IN THE UNITED STATES PATENT AND TRADEMARK OFFICE

For : ADJUSTABLE FILTER CIGARETTE

PRELIMINARY AMENDMENT

Fig. 3

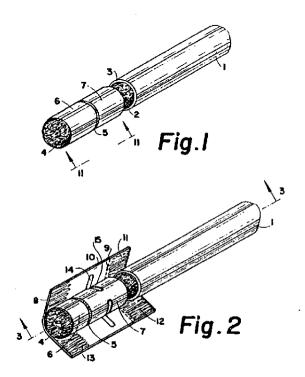
FIG. 3, delete the broken line between the perforations 9;

Fig. 13

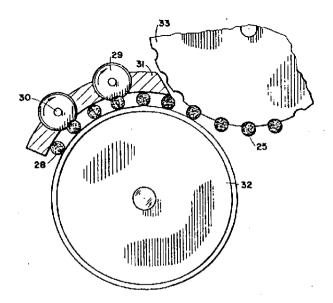
FIG. 13, change reference numeral "25" to --28--; which are indicated in red on the attached copies, so that they may be made by a commercially bonded draftsman.
